VILLAGE OF ESTERO
PLANNING ZONING AND DESIGN BOARD MEETING
PACKET
AUGUST 24, 2021, 04:30 PM

- a. Via Coconut (District 5) -- Rezoning (DCI2019-E003) & Right of Way Vacation (VAC2019-E001)**
8990 Corkscrew Road, 21650 & 21750 Via Coconut Point, 21331, 21350 & 21351 Happy Hollow Lane. Properties are located south of Corkscrew Road and west of Via Coconut Road.

CASE TYPE: Planned Development Rezoning – Vacation of Right-of-Way

Via Coconut MPD Estero Planned Development Summary of Planning & Zoning Board Public Informational Meeting

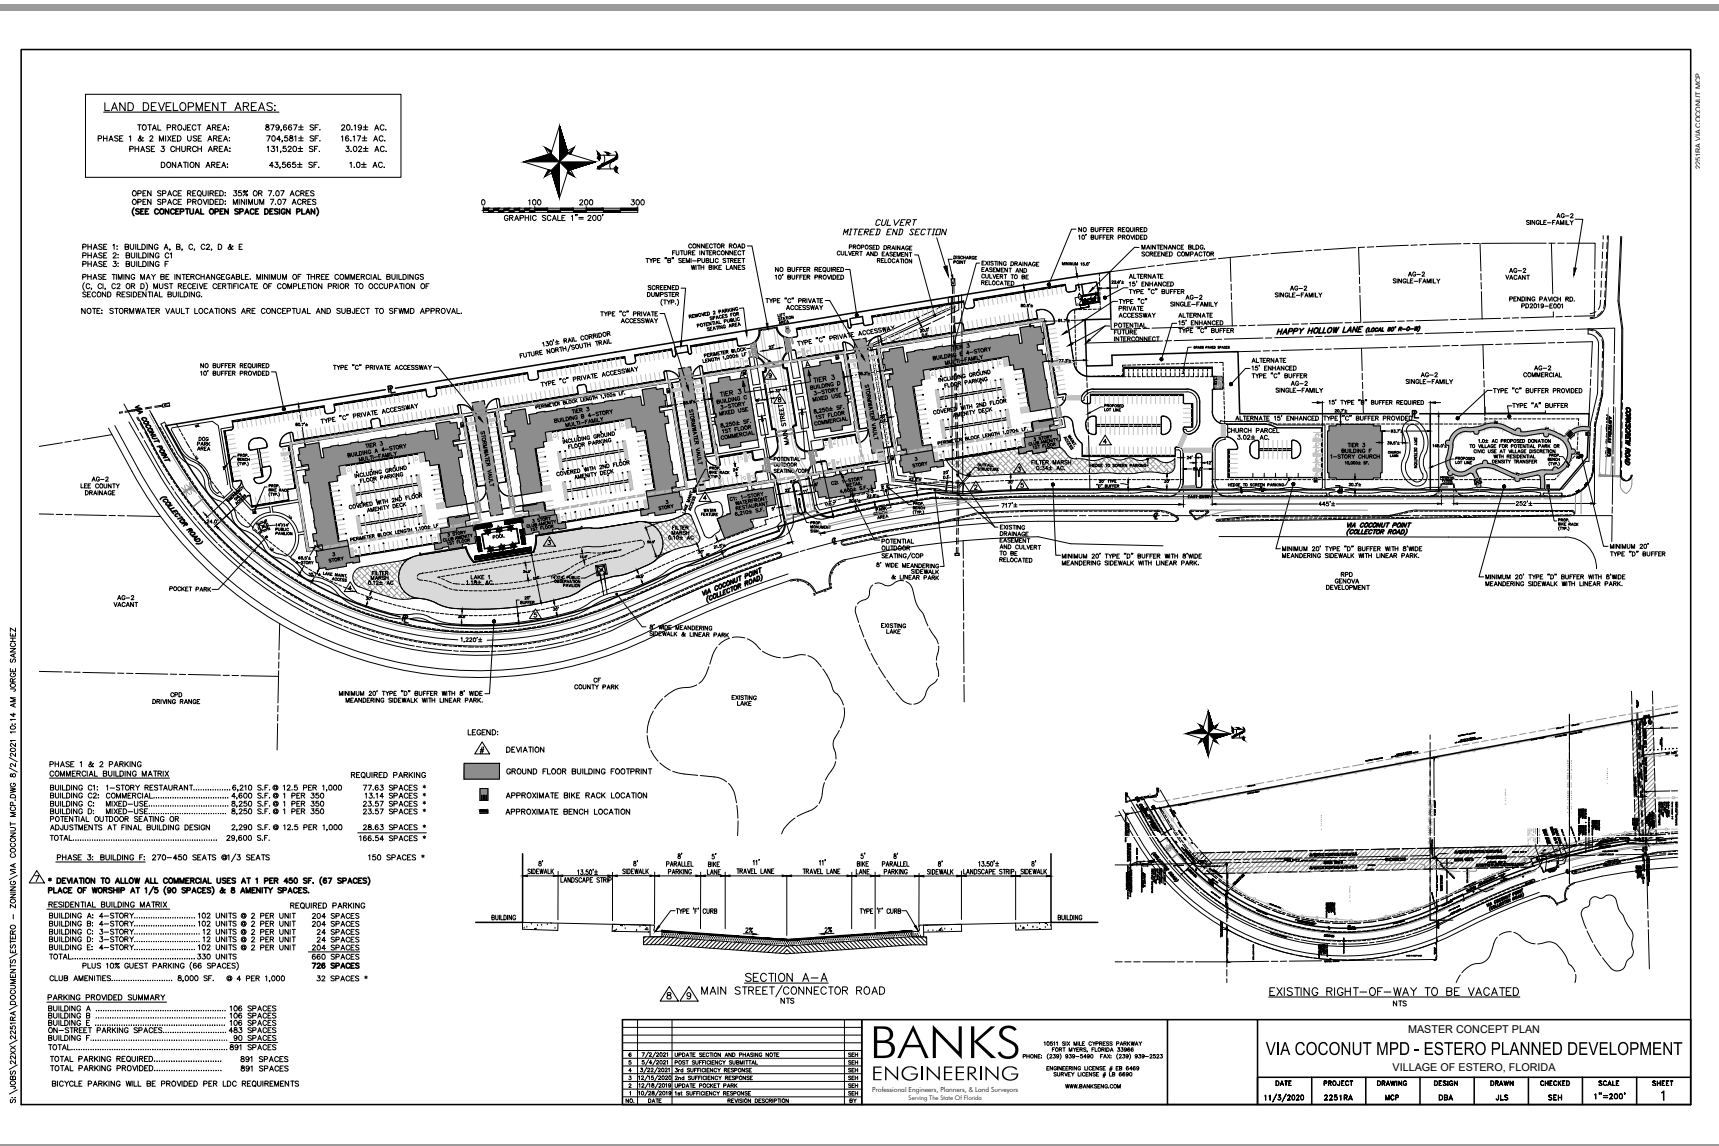
Comment: Buildings are plain.

Response: We would suggest simple, not plain, but please review the new architecture.

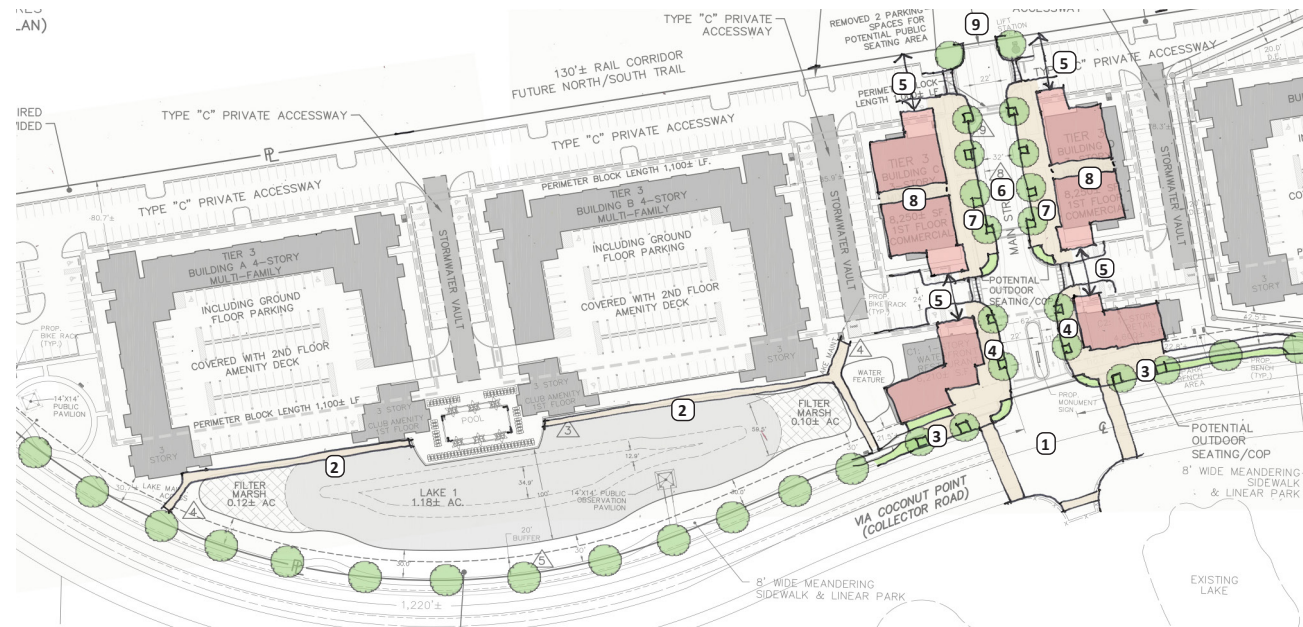
2.1: Good example of usable sidewalk space (but missing shade trees).

2.2: Attention to pavement design using flush curbs and bollards, street trees and seating.

2.3: The streetscape design used overhead light fixtures to enhance the placemaking potential of the street.

5.1: Sketch overlay

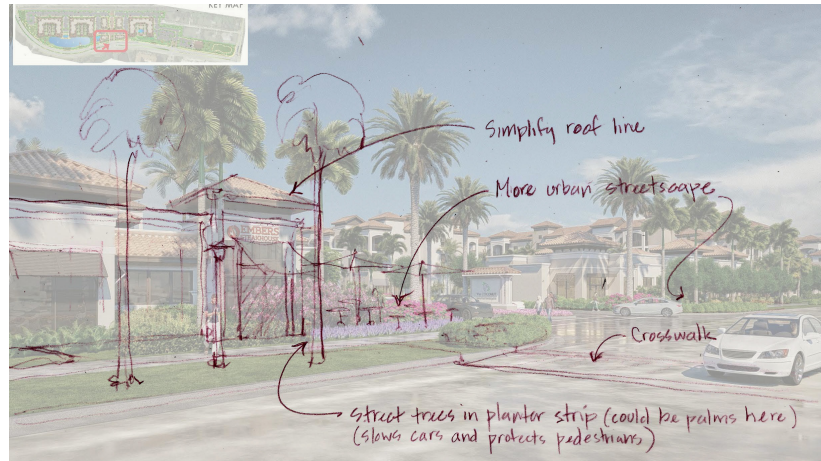
The massing and roof line seems overly complex for the scale of the building, with too many vertical divisions. The massing and roof line could be simplified to create a "calmer" composition and give better emphasis to selected vertical elements.
